## MEMORANDUM

Subject: Otay Ranch Village 7 Fire Protection Plan Addendum and Figures updates

## **Item 1. Approved 2005 Fire Protection Plan ADDENDUM – PROPOSED AMENDMENTS AND LAND USE CHANGES.**

### **Proposed Land Use Plan:**

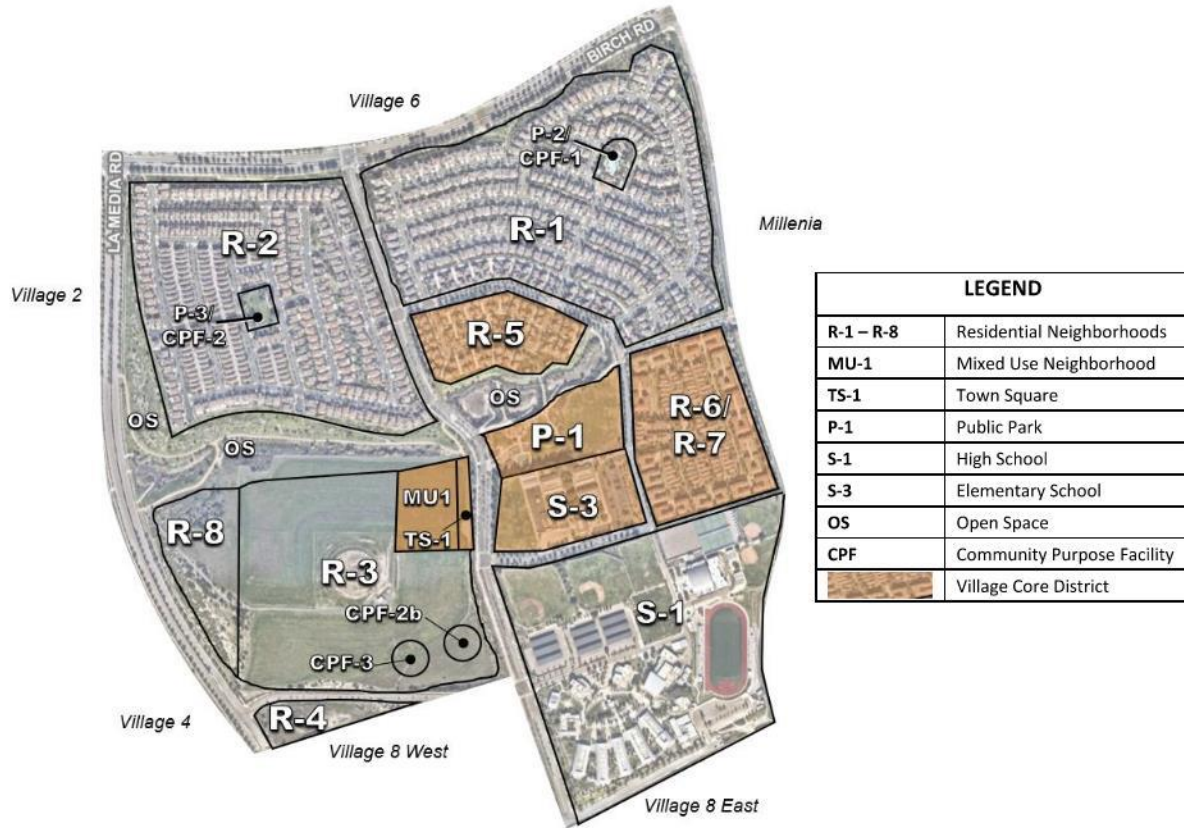
- Change to parcels designated “Single Family Three” to “Residential Multi-Family One” (SF3 to RM1) within western portion of the neighborhood R-3;
- Change the parcel designated as R-4 from “Single Family Four” to “Residential Multi-Family Two” (SF3 to RM2);
- Change the boundary of the R-3 neighborhood, and create a new neighborhood “R-8” using the amended portion of R-3.
- Reallocate 184 residential units out of the remaining 336 units from the single-family residential use category to the multi-family use category as follows:
  - Reduce single-family units in neighborhood R-3 from 228 to 44
  - Increase residential units in neighborhood R-4 from 59 single-family to 120 multi-family units
  - Allocate 123 multi-family residential units to the newly created neighborhood R-8

The proposed modifications do not result in an overall increase of the residential units in Village Seven beyond the 1,456 units that are currently approved in the Village Seven SPA Plan and what was studied in the Village Seven FEIR and the approved Fire Protection Plan. The proposed modifications redistribute the existing dwelling units between neighborhoods R-3, R-4 and the newly created neighborhood R-8 (what is currently the westernmost portion of R-3). The change in residential density will allow for housing types that are more appropriate for their specific location based on the existing surrounded development that has been completed and the changes in the adjacent land uses that have occurred over the past eighteen years since Village Seven village concept was initially conceived and approved. The proposed modifications would not require an expansion of the development footprint from that studied in the Village Seven FEIR.

Revised Land Use Map - R-3, R-4, R-8, MU-1, and TS-1

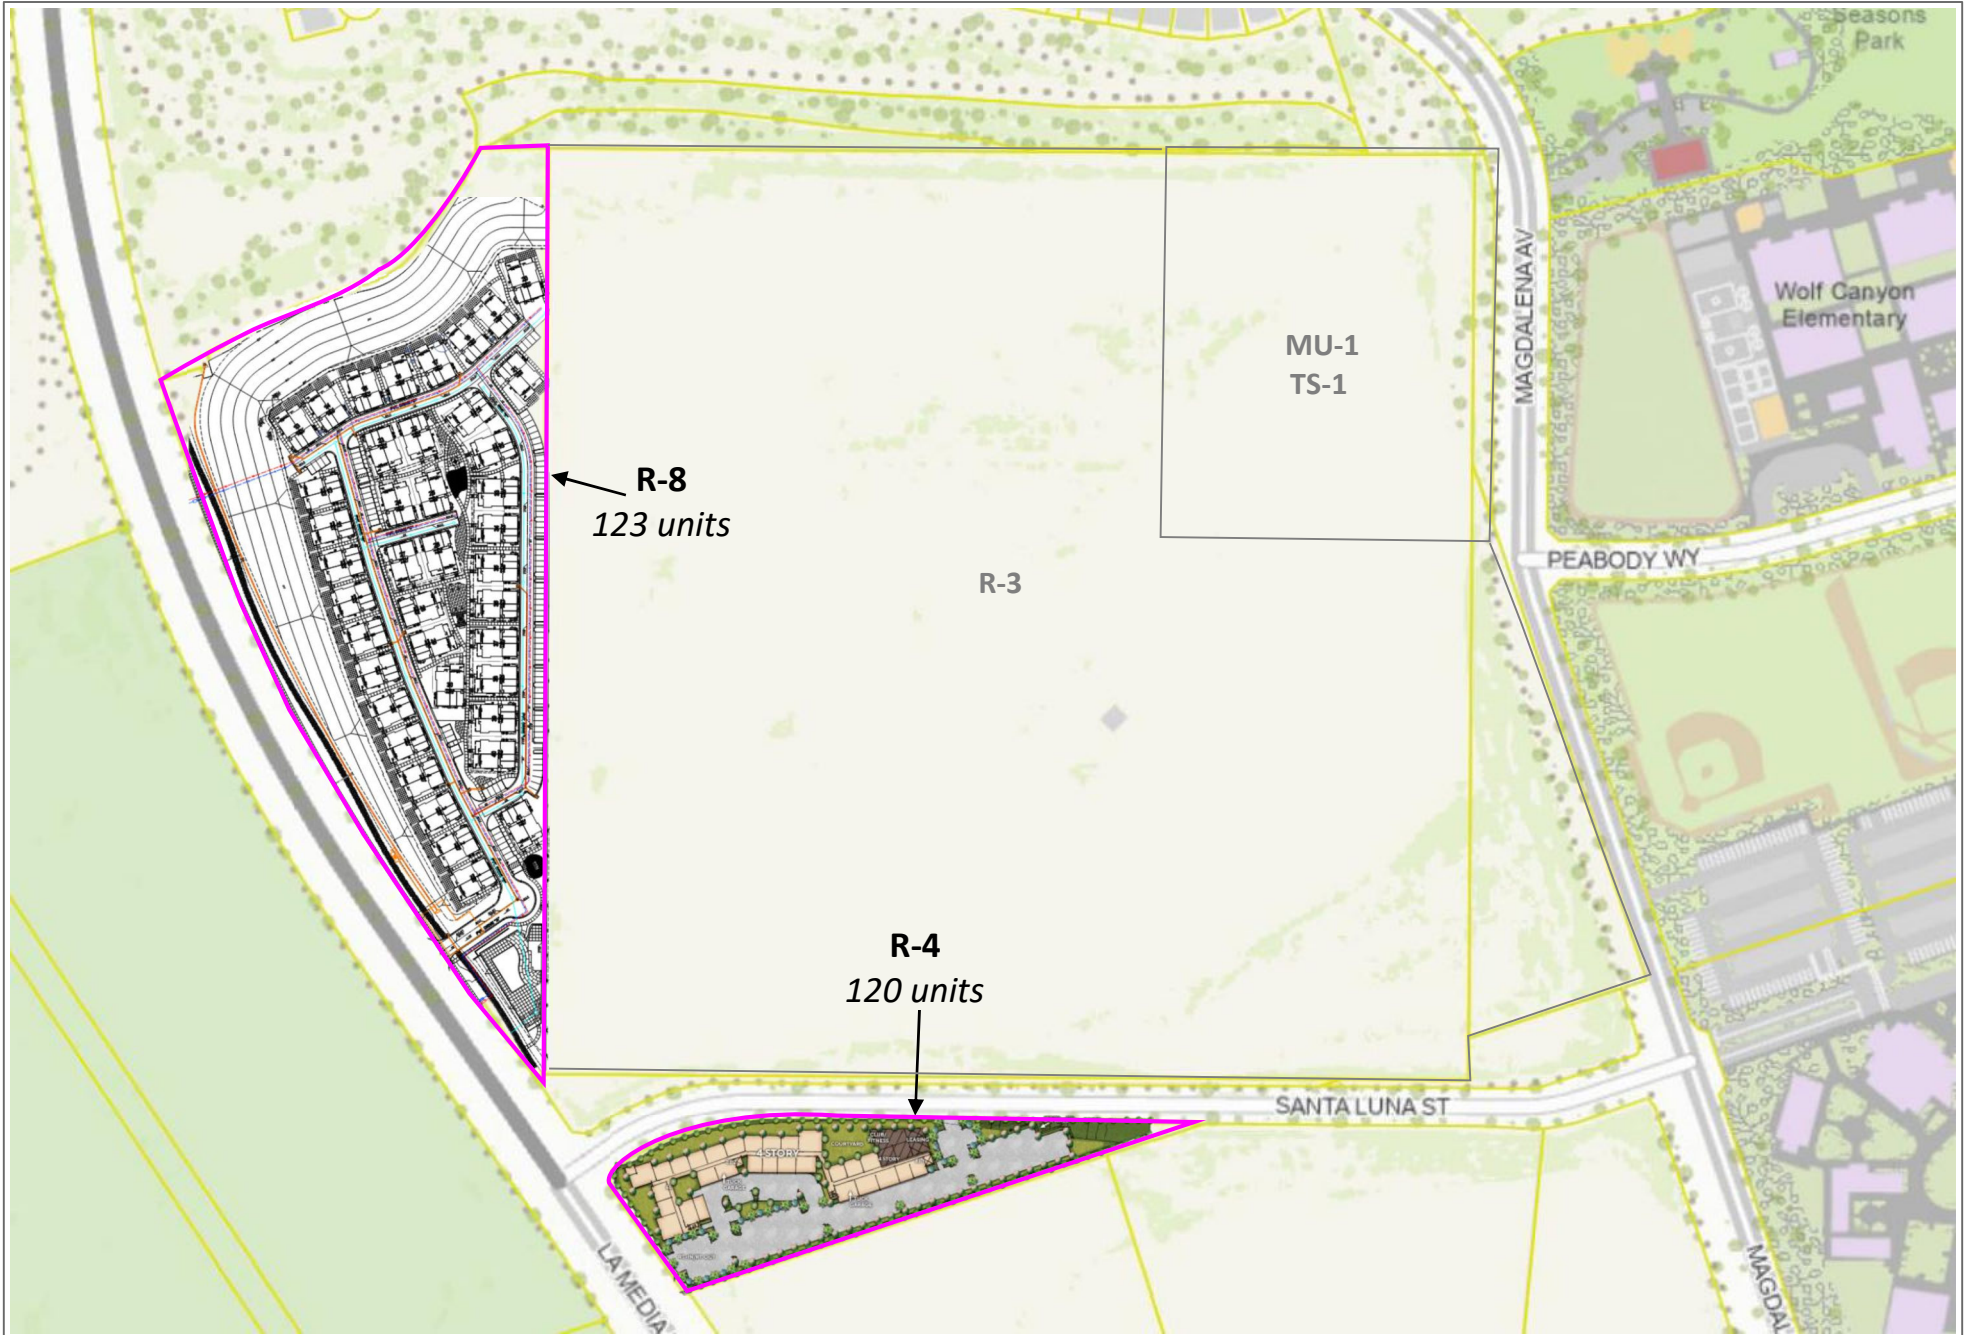
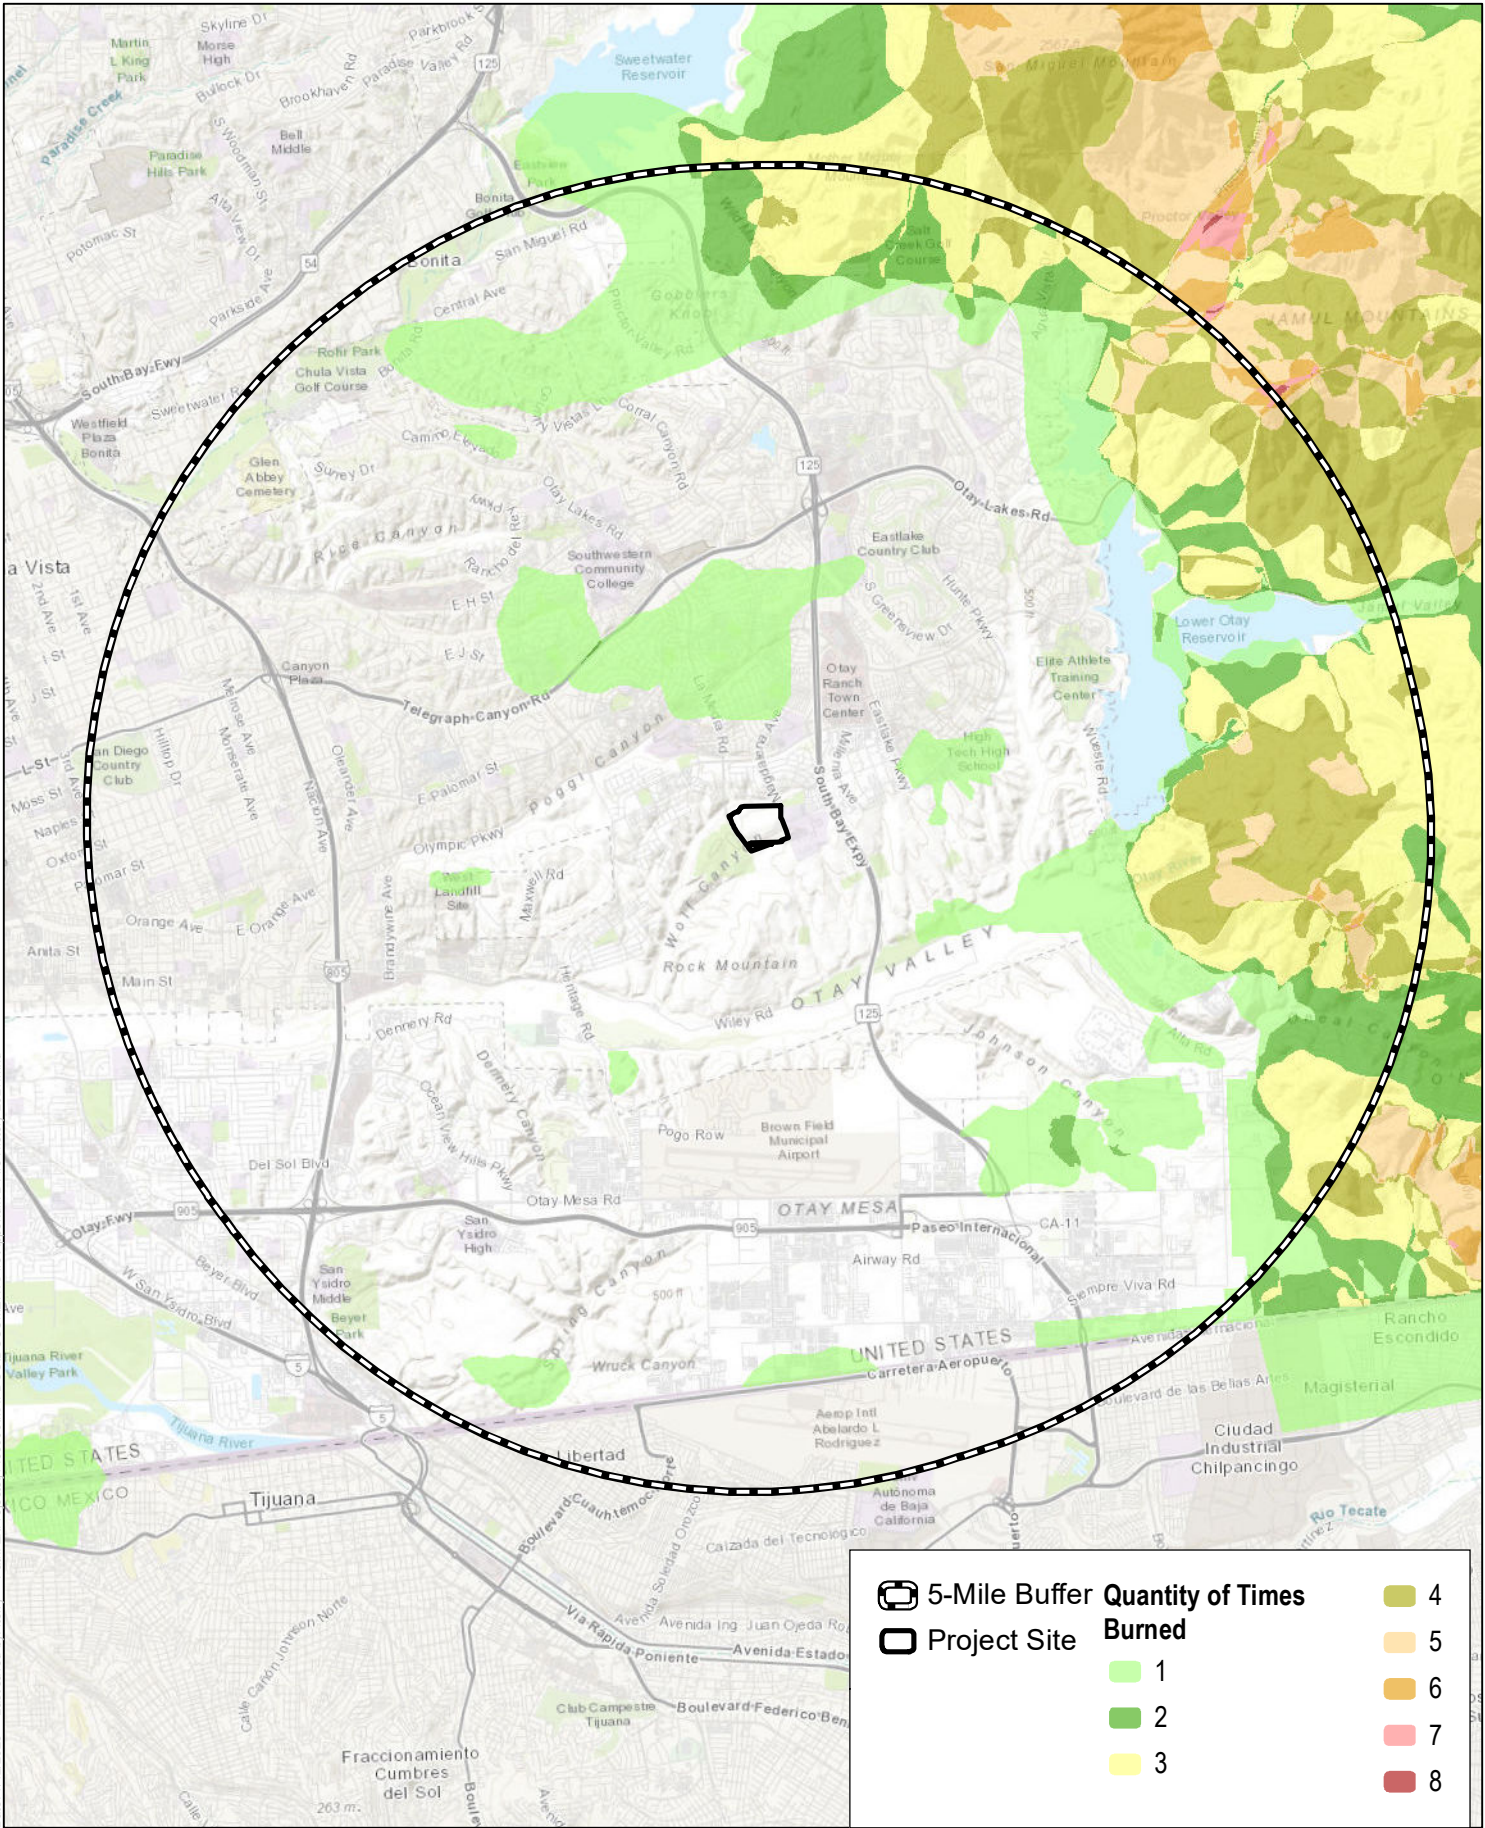
- Update the Chula Vista General Plan land use maps and tables to change the land uses for a 12.6-acre portion of R-3 along La Media Road from Low-Medium Residential (LM) to Medium (M) Residential, and R-4 from Low-Medium Residential (LM) to Town Center (TC).

- Update the Otay Ranch GDP land use maps and tables to change the land uses for a 12.6-acre portion of R-3 along La Media Road from Low-Medium Village (LMV) Density Residential to Medium (M) Density Residential, and R-4 from Low-Medium Village (LMV) Density Residential to Town Center (TC).

- Change the land use designation of the western portion of the neighborhood R-3 from Single Family Three (SF3) to Residential Multi-Family One (RM1)
- Change the land use designation in neighborhood R-4 from Single Family Four (SF4) to Town Center (RM2).
- Change the boundary of the existing neighborhood R-3, create a new neighborhood R-8 from the rezoned portion of R-3, and transfer units between neighborhoods R-3, R-4 and R-8.
- Update SPA Plan text, tables, and exhibits to reflect the proposed land use changes.
- Update SPA Appendices – Planned Community District Regulations, Village Seven Design Plan, Air Quality Improvement Plan, Water Conservation Plan, Non-Renewable Energy Conservation Plan, and technical studies to reflect the SPA Amendment.
